CITY OF WHEELING PLANNING COMMISSION

STAFF REPORT

PROPERTY LOCATION: 1035 Mt. de Chantal Road [see Exhibit 1]
Parcels 120, 144, and 145, Tax Map W53, Tax District 10

NATURE OF REQUEST: Preliminary and Final Site Plan Approval

SITE PLAN

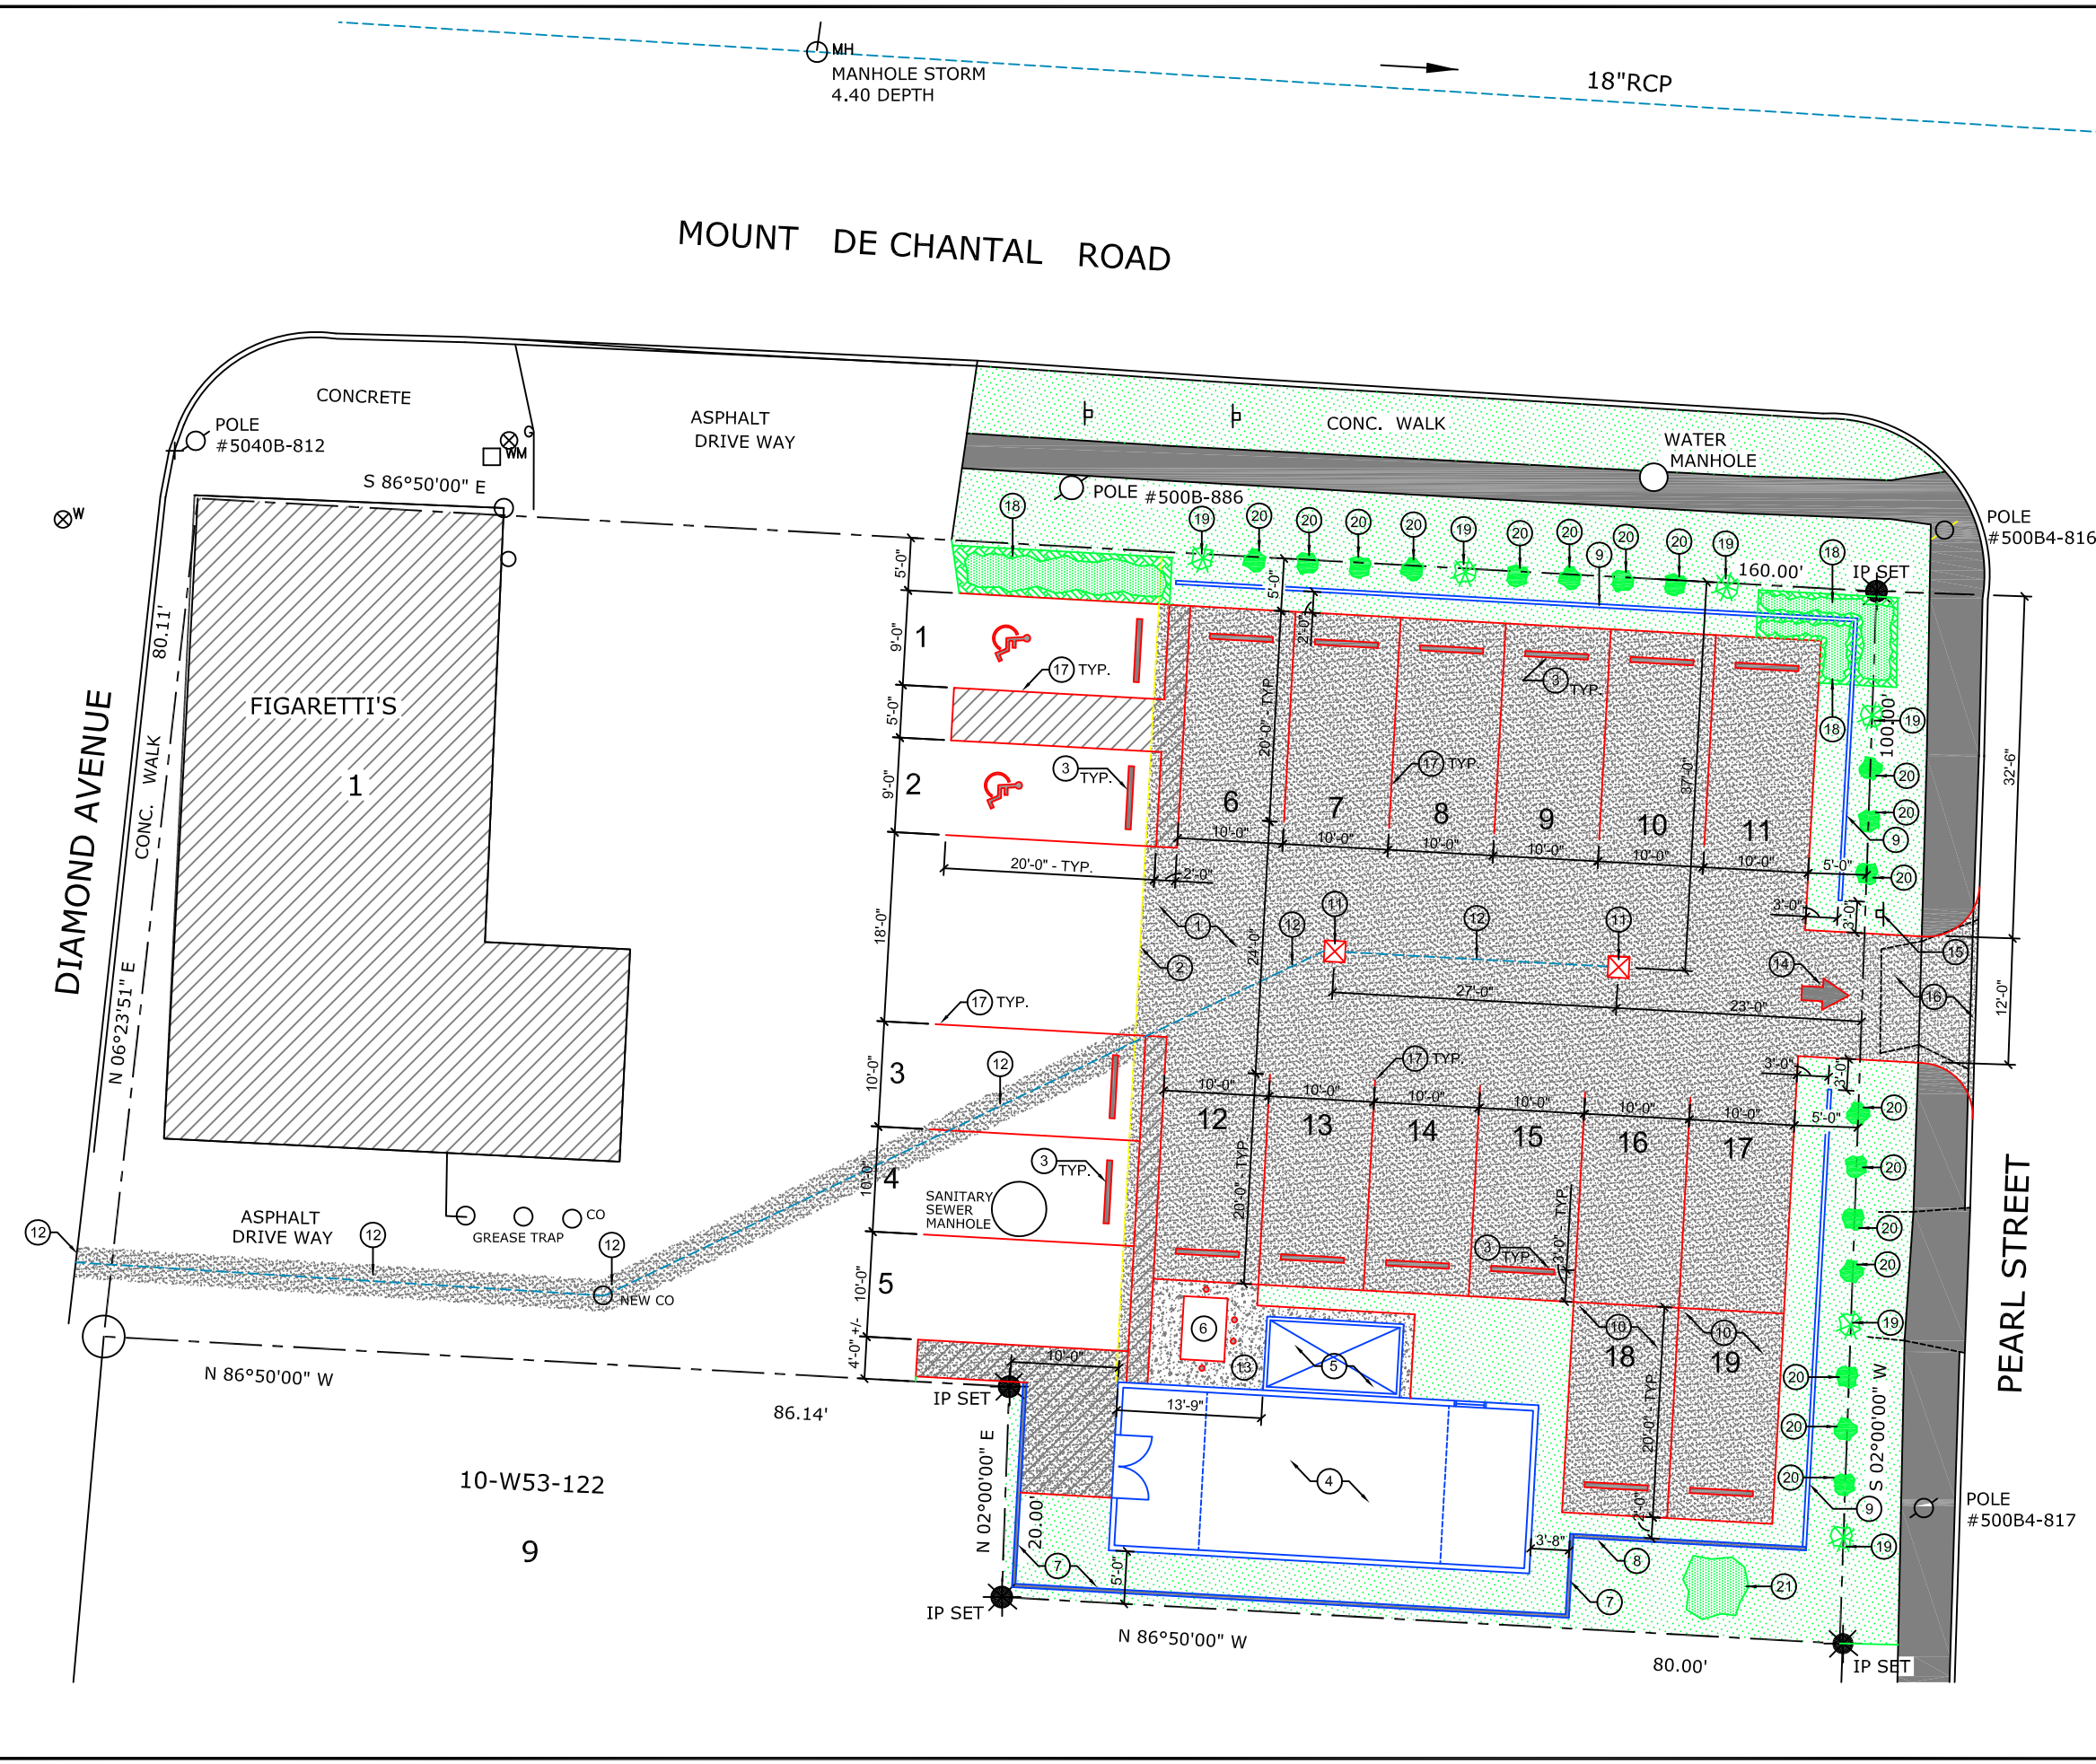
Although the proposed building is an accessory storage/cooler building for the Figaretti's Restaurant, its planned location on the site, setback, and screening methods appears to demonstrate regard to the adjoining residential use and neighborhood. Variance relief from Article 1355.03(a) is required to permit parking spaces to be developed within the minimum 10-foot front yard setbacks along Mt. de Chante Road and Pearl Avenue for the subject corner lot, the proposed parking space setback for which is five (5) feet within said front yards.

The proposed screening strategy for the accessory storage/cooler building and accessory parking utilizes hardscape and softscape materials common to residential uses thereby advancing an acceptable transitional design solution between the commercial restaurant use and the adjoining residential zoning district and neighborhood.

The image to the right is clipped from the applicant's integrated Site Plan and Landscape Plan, with emphasis added highlighting the applicant's design care to incorporate:

- Appropriate opaque and open fencing at varying heights to screen the site and headlights from parking vehicles from the adjoining dwelling unit and provide a vertical edge separating the vehicular space of the parking area and the adjoining pedestrian space along the public sidewalks.
- Landscaping materials that soften the edges of and buffer the site along Mt. de Chantal Road and Pearl Avenue and their respective sidewalks, thereby augmenting the screening function of the proposed fencing.

- Variance relief from 1355.04(b) waiving the requirement to develop full depth concrete or granite block curbing along the perimeter of proposed parking area.
- Variance relief from the following interior parking area landscaping requirements:
 - Variance relief from Article 1355.05(a) to permit the one (1) requisite major deciduous shade tree to be planted outside the parking area instead of within the parking area; and,
 - Variance relief from Article 1355.05(b) and Article 1373.07(d)(7) waiving the requirement to develop interior parking area raised planting islands.

The image to the right of the applicant's the site plan includes staff illustrative emphasis. Although not to scale, the blue area generally illustrates the flow of vehicles entering the site from Mt. de Chantal Road, queuing for curbside carry-out, and then maneuvering to exit the site onto Diamond Avenue.

The red dashed/circled areas identify existing conflict/congestion points, which will remain for vehicles exiting the new parking area through the existing site rather than onto Pearl Avenue.

The development's primary objectives are to reduce on-street parking congestion and improve site efficiency to better accommodate both dine-in and carry-out customers. The site is limited by fixed space and geometry. The applicant appears to have employed site design strategies with an understanding and view of both on-site and off-site effects and benefits, paying particular care to the proposed driveway access onto Pearl Avenue. Specifically, the proposed driveway access to Pearl Avenue will be exit only, signed and designed to prohibit/restrict entry from Pearl Avenue, thereby reducing adverse impacts on Pearl Avenue movements and neighboring residential properties.

As discussed under General Standard (H) above concerning driveway connections to public streets, it appears the applicant has demonstrated care in maximizing the number of onsite parking spaces while reducing onsite circulation congestion resulting from the curb-site carry-out service the restaurant now offers. The location of and dimensional layout for the parking spaces, parking areas, and drive aisles appear to meet the Planning and Zoning Code's related development and performance standards.

The site appears to incorporate adequate solid waste storage facilities for the proposed restaurant and appears to include bollards at the rear of the dumpster pad to protect the proposed accessory storage/cooler building from potential damage resulting from replacing the dumpster after being collected by the hauler. The restaurant operator will ultimately be responsible for securing adequate service with the solid waste and recycling hauler (i.e., dumpster size, number of pickups per week, etc.).
